SUNDRY NOTICES AND REPORTS ON WELLS

Thompson Engineering plans to plug and abandon the Rudman Federal #1 according to the attached procedure.

P & A Procedure for
Thompson Engineering and Production Corp.
Rudman Federal #1

Re: Permanent Abandonment
Well: 1 Rudman Federal

Wellbore Schematic

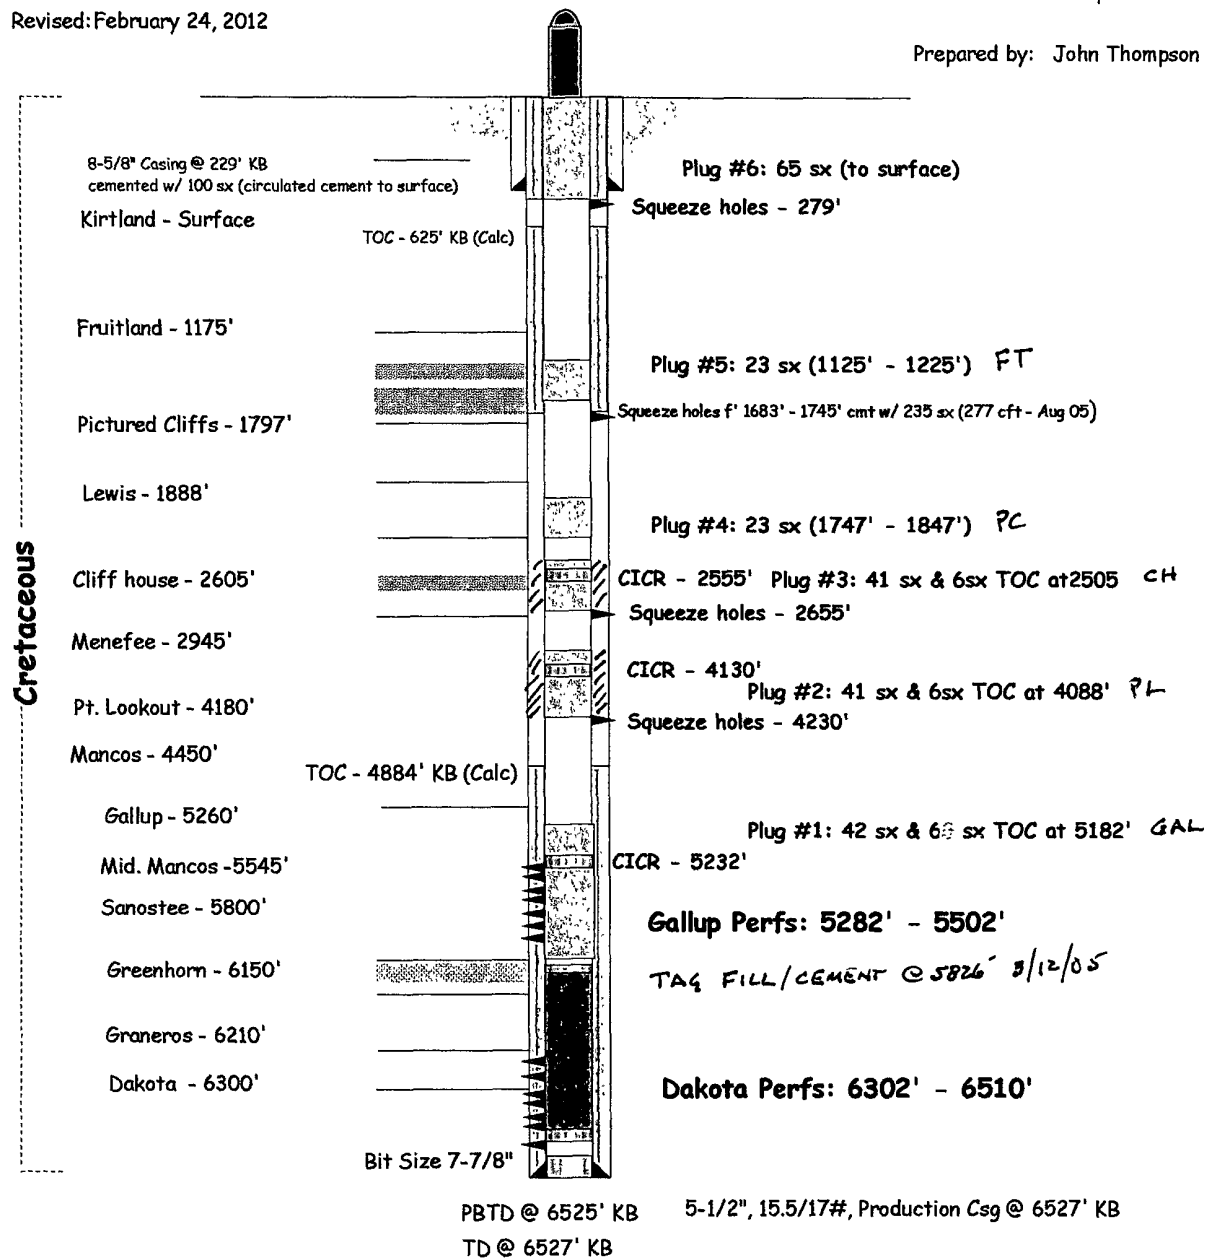
* Place mancos plug inside /outside from 4400-4500

13. POH to ~~1225'~~¹⁵⁵⁷. **Plug #5**. Spot a balanced plug from ~~1125'~~¹⁴⁵⁷ to ~~1225'~~ (50' +/- the Fruitland top) with 100' excess. Use 23 sx (27.1 cu.ft.) of Cl "B" or equivalent neat cement. TOH.
 → *K. Fruitland / Old Alumna plug 1225 - 911*

1. Plugging operations authorized are subject to the attached "General Requirements for Permanent Abandonment of Wells on Federal and Indian Lease."
2. Farmington Office is to be notified at least 24 hours before the plugging operations commence (505) 599-8907.
3. The following modifications to your plugging program are to be made:
 - a) Place the Fruitland plug from 1557' – 1457'.
 - b) Place the Kirtland/Ojo Alamo plug from 1225' – 911'.

You are also required to place cement excesses per 4.2 and 4.4 of the attached General Requirements.
